Well Name: JAMES RANCH UNIT DI 7 SAWTOOTH	Well Location: T23S / R31E / SEC 6 / LOT 4 / 32.340052 / -103.82215	County or Parish/State: EDDY / NM
Well Number: 704H	Type of Well: OIL WELL	Allottee or Tribe Name:
Lease Number: NMNM02953C	Unit or CA Name: JAMES RANCH UNIT	Unit or CA Number: NMNM70965X
US Well Number:	Operator: XTO PERMIAN OPERATING LLC

Type of Submission: Notice of Intent      Type of Action: APD Change

**Procedure Description:** XTO Permian Operating, LLC. respectfully requests approval to make changes to the approved APD as follows: SHL, FTP, LTP, BHL, change the proposed TD and update the casing and cement program as follows: FROM: TO: SHL: 260' FNL & 1069' FWL of Section 6-T23S-R31E 155' FNL & 1100' FWL of Section 6-T23S-R31E FTP: 700' FSL & 2310' FWL of Section 31-T22S-R31E 330' FNL & 2530' FWL of Section 6-T23S-R31E LTP: 2539' FNL & 2310' FWL of Section 18-T23S-R31E 2540' FNL & 2530' FWL of Section 18-T23S-R31E BHL: 2589' FNL & 2310' FWL of Section 18-T23S-R31E 2590' FNL & 2530' FWL of Section 18-T23S-R31E The proposed TD will change from 24317' MD; 9976' TVD (Bone Springs) to 22259' MD; 9827' TVD (Bone Springs). The casing and cement program will be updated as

WELL LOCATION AND ACREAGE DEDICATION PLAT

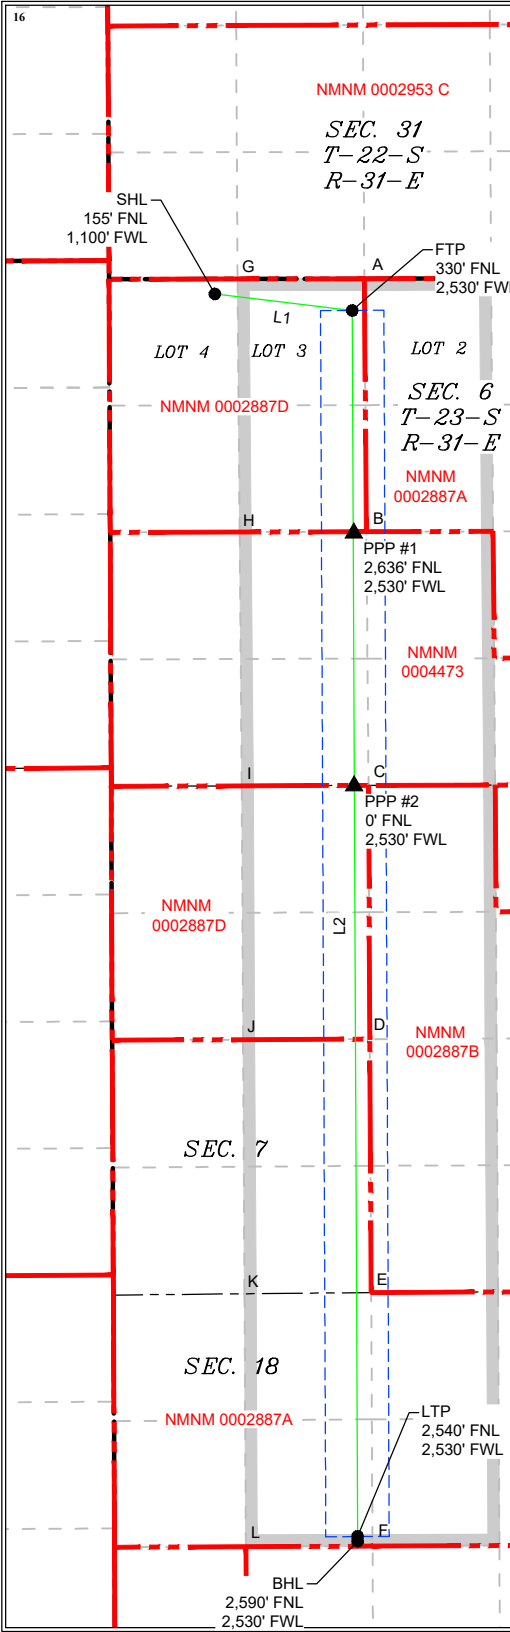
XTO Permian Operating, LLC. respectfully requests approval to make changes to the approved APD as follows: SHL, FTP, LTP, BHL, change the proposed TD and update the casing and cement program as follows:

FROM: TO:  
SHL: 260' FNL & 1069' FWL of Section 6-T23S-R31E 155' FNL & 1100' FWL of Section 6-T23S-R31E  
FTP: 700' FSL & 2310' FWL of Section 31-T22S-R31E 330' FNL & 2530' FWL of Section 6-T23S-R31E  
LTP: 2539' FNL & 2310' FWL of Section 18-T23S-R31E 2540' FNL & 2530' FWL of Section 18-T23S-R31E  
BHL: 2589' FNL & 2310' FWL of Section 18-T23S-R31E 2590' FNL & 2530' FWL of Section 18-T23S-R31E

The proposed TD will change from 24317 MD; 9976 TVD (Bone Springs) to 22259 MD; 9827 TVD (Bone Springs).
